Volvo S40 / V40

From chassis no. 0000001 to 414999

Failure of the ABS system.

Bulletin

Fig. 1 (plug up to model year 1997)

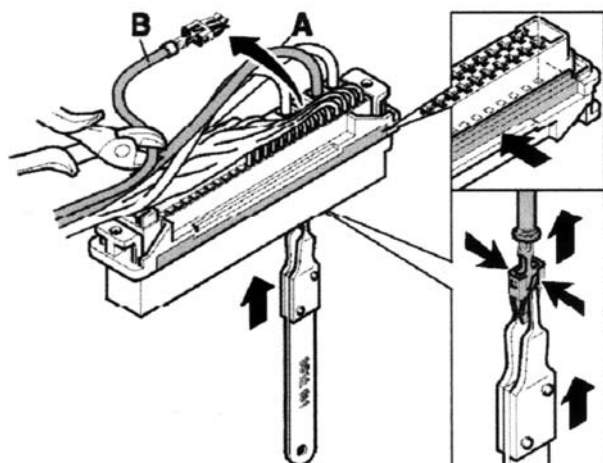
- Note the radio code and disconnect the battery.
- Disconnect the connecting plug from the ABS unit.
- Open the connecting plug and remove the voltage supply cable (up to model year 1997 pins 2 and 3, from model year 1998 pins 17 and 18). Cut the cables off as far as possible before the insulation (Fig. 1).

- Insert the new cables in the connecting plug (which cable is inserted in which slot is not important).
- Check the ground connections in the connecting plug for corrosion.
